Project	IEEE 802.16 Broadband Wireless Access Working Group < http://ieee802.org/16 >	
Title	EAP-based Authentication Procedure and Primitives	
Date Submitted	2005-07-11	
Source(s)	Mi Young Yun	myyun@etri.re.kr
	Jung Mo Moon, PhD	jmmoon@etri.re.kr
	Sang Ho Lee, PhD	leesh@etri.re.kr
	ETRI	
	161, Gajeong-dong, Yuseong-gu,	Voice: 82-42-860-4821
	Daejeon, 305-700, Korea	Fax: 82-42-861-1966
Re:	Contribution on comments to IEEE 802.16g-04/03r3	
Abstract	In this contribution, we describe the EAP authentication procedure and service primitives that could be exchanged between the BS and the NCMS entities.	
Purpose	Adoption	
Notice	This document has been prepared to assist IEEE 802.16. It is offered as a basis for discussion and is not binding on the contributing individual(s) or organization(s). The material in this document is subject to change in form and content after further study. The contributor(s) reserve(s) the right to add, amend or withdraw material contained herein.

EAP-based Authentication Procedure and Primitives

Figure 1. EAP-based authentication procedure using Diameter protocols[1][2]

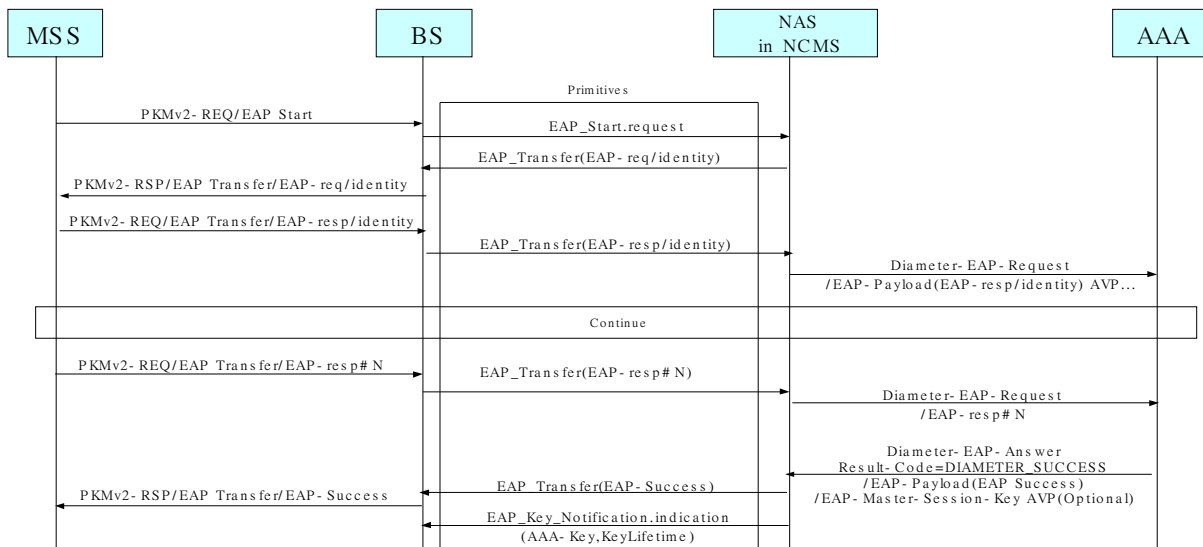
[Insert section 14.5.5.5 as follow]

14.5.5.5 EAP-based authentication procedure

When an MSS try to initiate an EAP-based authentication or re-authentication procedure with a BS, it sends a PKMv2 EAP Start message. The BS informs of an NAS (Network Access Server) entity in NCMS as an EAP_start.request primitive. If the MSS receives EAP-Request/Identity messages, then it sends the EAP-Response/Identity message with MN's identifier to the NAS entity. After the EAP-Response/Identity message, the EAP methods are negotiated between the MS and the AAA server and the EAP messages are exchanged several times. The EAP messages encapsulated are exchanged between the MSS and the NAS entity. If the EAP authentication procedure is finished successfully and also yields an AAA-key, the BS which does not know EAP protocols receives the AAA-key and a key lifetime from the EAP client entity as an EAP_Key_Notification.indication primitive. It is already shared between the AAA server and the MSS through the EAP exchanges. The AAA-key is used for derivation for a PMK (Pair wise Master Key) and optional EIK (EAP Integrity Key). Figure 1 shows EAP-based authentication procedure between a BS and an NAS entity in NCMS as follows
